## MEMORANDUM

To: Zoning Board  
From: Lauren A. Wasilauski, Open Space & Stewardship Director  
Date: March 14, 2024  
Re: BA-07-23: Bedens Brook Club  
Block 31001 Lots 38 & 39 (240 Rolling Hill Road)  
Minor Site Plan and Use Variance

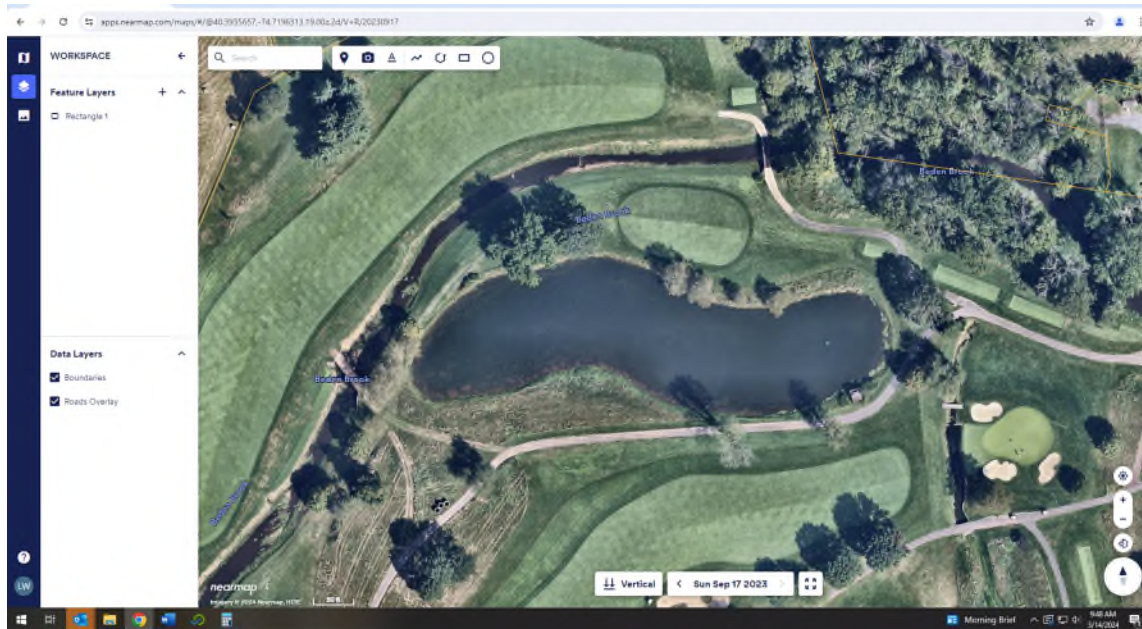
1. Sidewalks are required on all public streets per Code Section 16-5.14C, with the exception of properties located in the MR zoning district:

*“Except for all local, rural collector and scenic collector roads in the MR District, sidewalks shall be provided along all existing streets upon which all residential and nonresidential developments abut, unless specifically waived in certain locations by the reviewing municipal agency based upon good cause shown by the applicant, such as, but not limited to, the existence or proposal of alternate linkages for pedestrian movement and/or where other improvements are proposed to better facilitate the movement of people between the development and adjacent lands;”*

2. There are no sidewalks in the vicinity and the Applicant does not propose to construct any sidewalks.
